**Flood Control Project Maintenance  
Levee Inspections**

## Maintenance Issue Types Only, Levee Inspection Report By Mile - Fall 2015

### Reclamation District No. 0765 Glide

Waterway	Bank	Unit Miles	Inspection Start/End	Inspector
Unit No. 01 Sacramento River	Right	1.72	09/25/2015 09/25/2015	Richard Willoughby

Photo 1 of 2 : FA\_2015\_RD0765\_211\_5\_20150914\_00003.jpg

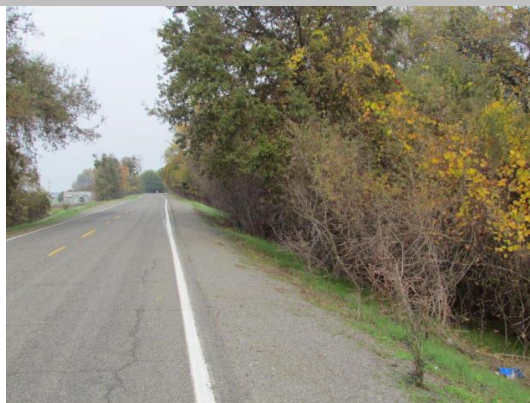
LM Start	1.42	Rating **	M	Issue No.	5
LM End	1.45	Issue Type +	Ma	Location *	WS
Category	Earthen Levee			GPS Latitude/Longitude	
				Start	End
Item	Trim / Thin Trees			38.483925 °	38.483530 °
				-121.551845 °	-121.551587 °
DWR ID	DWR_RD0765_01_s _ 2012_5				
Action/Comments					
Thin trees to allow visibility of the ground and room to flood fight.

Looking north at dense vegetation on waterside slope. (Fall Inspection 2012)
